PCI-SIG DRAFT - ENGINEERING CHANGE NOTICE

TITLE:	Root Complex Event Collector Bus Number Association
DATE:	DRAFT 5/21/2018
AFFECTED DOCUMENTS:	PCI Express Base Specification, Revision 4.0
SPONSOR:	Intel Corporation

This ECN enhances Root Complex Event Collectors (RCECs) to allow them to be associated with Devices located on additional Bus numbers.

Figure 1-1 Root Complex Event Collector Endpoint Association Extended Capability

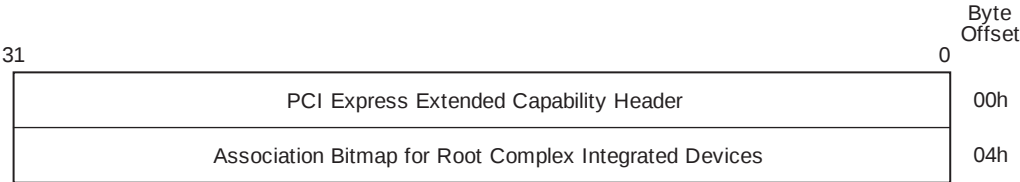
The Root Complex Event Collector Endpoint Association Extended Capability , as shown in Figure 1-1 Root Complex Event Collector Endpoint Association Extended Capability , consists of the ~~↓PCI Express Extended Capability ↓~~ **↑PCI Express Extended Capability ↑** header followed by a DWORD bitmap enumerating RCiEPs **↑on the same Bus, and optionally an additional range of Bus Numbers which may contain RCiEPs ↑** associated with the Root Complex Event Collector . **↑Functions other than RCiEPs (e.g. Root Ports) contained in the range described by this Capability are not associated with this RCEC. ↑**

↑ Figure needs to be updated with new register ↑
